Artesia Pump Station Improvements  
Solicitation Number: CO-00448-RL  
Job No.: 18-8603 and 14-6001

ADDENDUM 2  
July 23, 2021

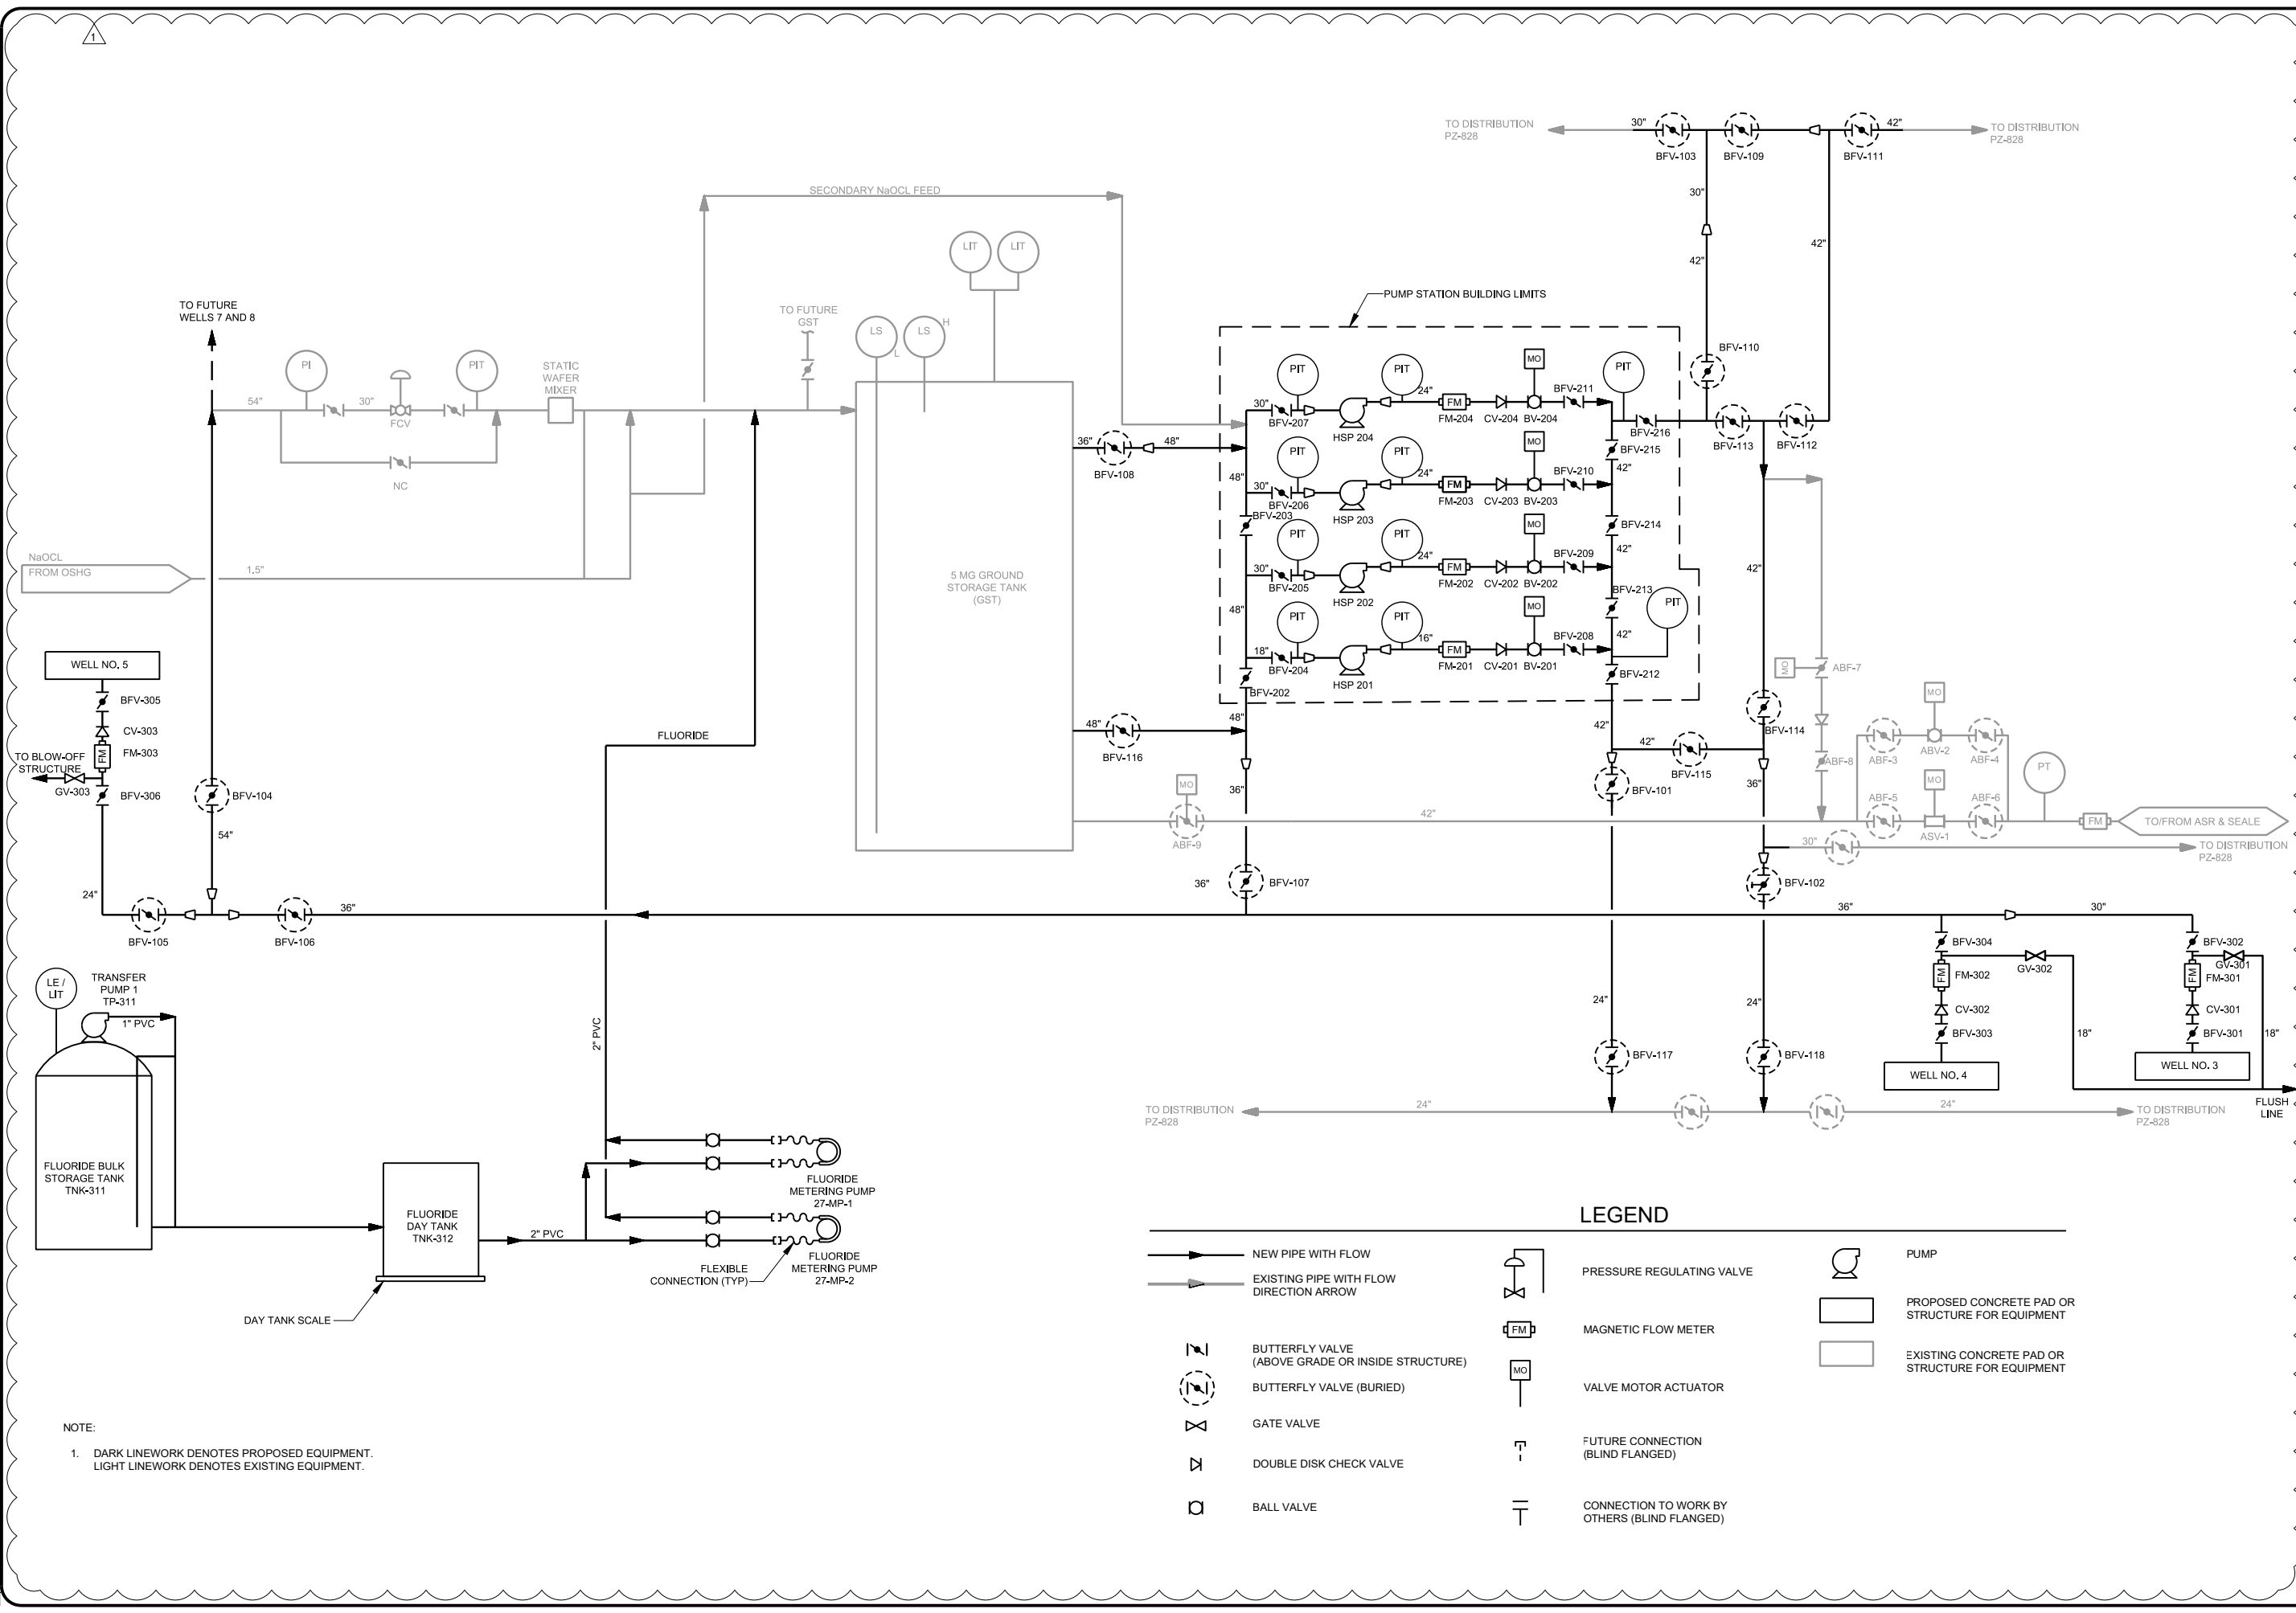
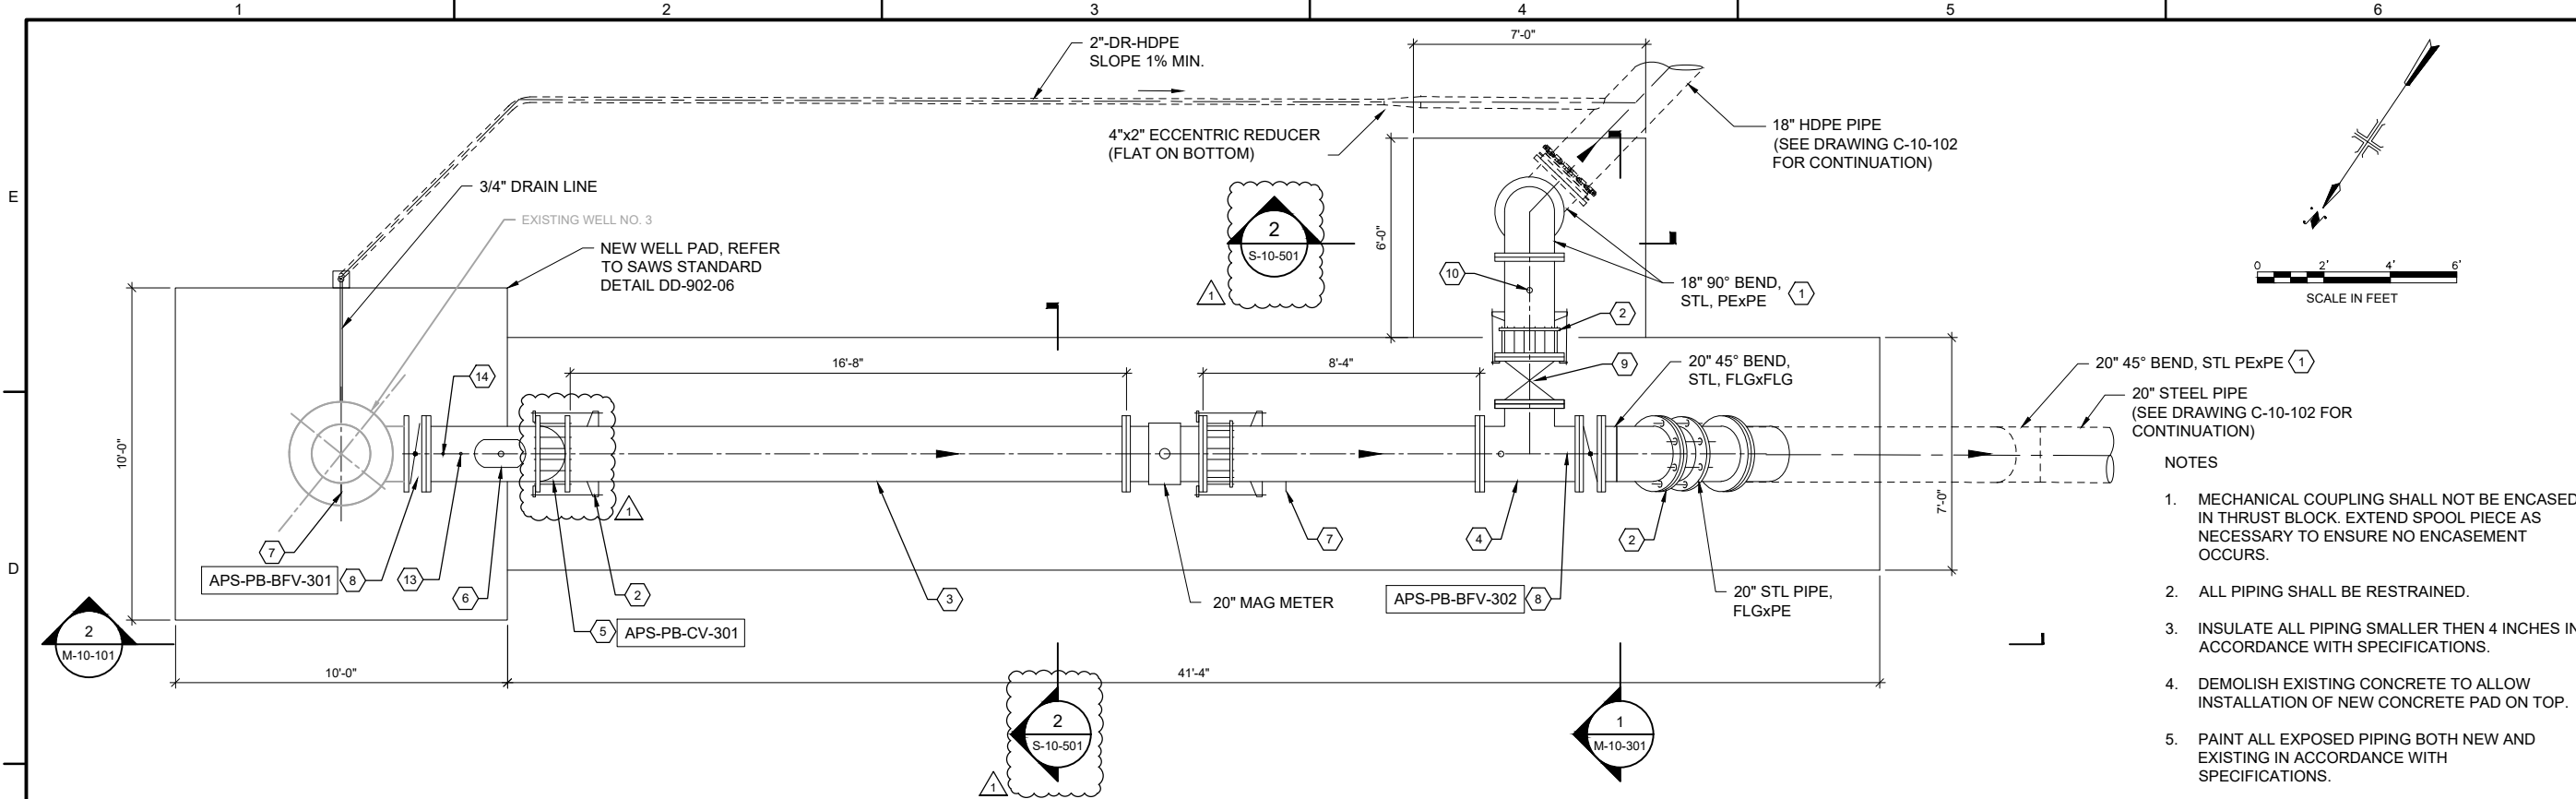
- a. In the valve schedule, BFV-104 should be 54" in size to match plan sheet 23 of 200 - left side.
- b. In the valve schedule, BFV-105 should be 24" in size and BFV-102 should be 36" in size to match plan sheet 7 of 200.
- c. On plan sheet 7 of 200, well 5 24" BFV-100 should be moved to the 24" line below BFV-102.
- d. On plan sheet 24 of 200, BFV-116 should be changed to BFV-117.
- e. On plan sheet 27 of 200, BFV-102 should be changed to 36" in size and BFV-118 should be changed to BFV-100.
- f. On plan sheet 28 of 200, BFV-117 should be deleted to match plan sheet 7 of 200.

- b. BFV-105 shall be revised to 24" in the valve schedule. See Changes to Specifications Item #14 within this Addendum. BFV-102 is 24" and Sheet 7 will be revised per Changes to Drawings Item #2 within this Addendum.
- c. BFV-100 shall be removed from the schedule. Additional valve BFV-118 shall be shown on the 24" line below BFV-102. See Changes to Specifications Item #14 within this Addendum.
- d. BFV-116 will remain as is on Sheet 24, but Sheet 7 will be revised per Changes to Drawings Item #2 and Changes to Specifications Item #14 within this Addendum.
- e. BFV-102 will remain as a 24" and BFV-118 will remain as shown on Sheet 27. Sheet 7 will be revised per Changes to Drawings Item #2 and Changes to Specifications Item #14 within this Addendum.
- f. BFV-117 will remain as is on Sheet 28 and Sheet 7 will be revised per Changes to Drawings Item #2 within this Addendum.

8. All pipe joints shall be welded for buried steel pipe.
2. Delete Sheet 7 (G-00-007) and Replace with the revised Sheet 7 in this Addendum included as Attachment 3.
3. On Sheet 49 (C-01-136) Revise the callout for the 24” Emergency Drain from “24” RCP” to “24” Steel Pipe”.

**1 WELL NO. 3 PLAN**

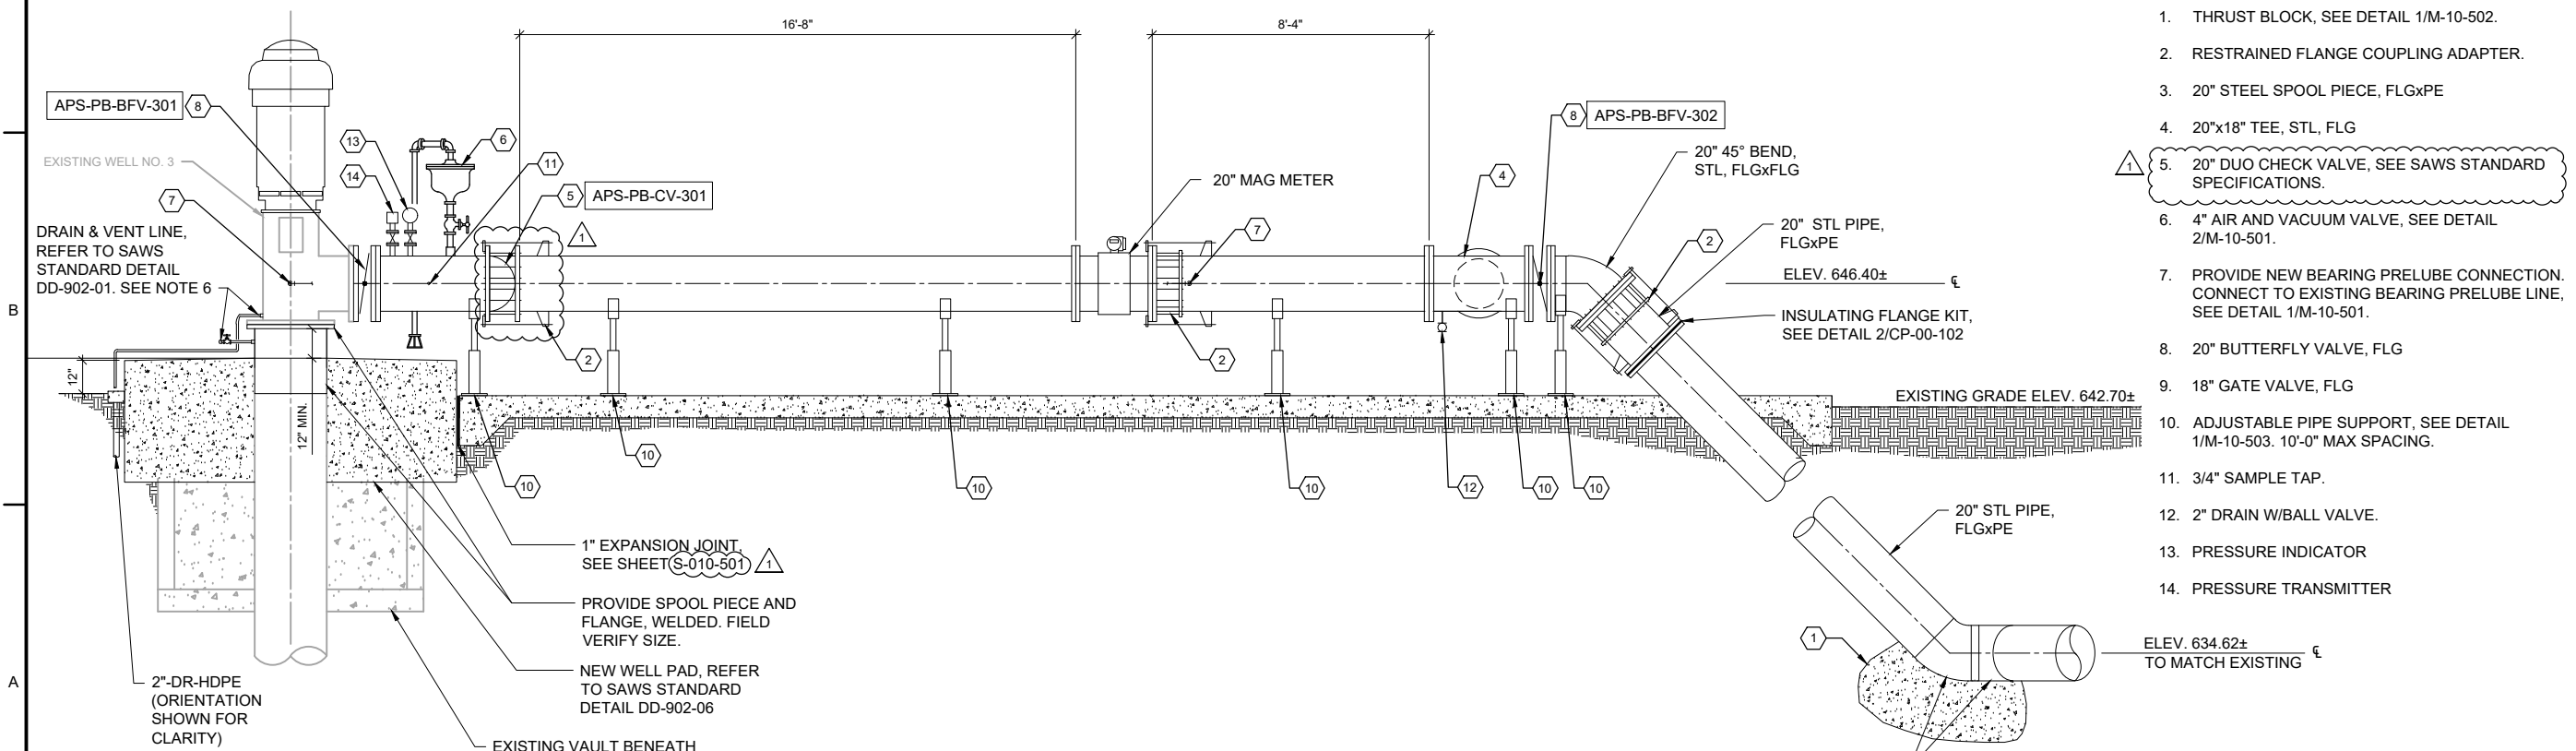
16. Delete Volume 2 – Sheet 13 (M-10-101) and Replace with the revised Sheet in this Addendum included as Attachment 4.
17. Delete Volume 2 – Sheet 14 (M-10-102) and Replace with the revised Sheet in this Addendum included as Attachment 5.
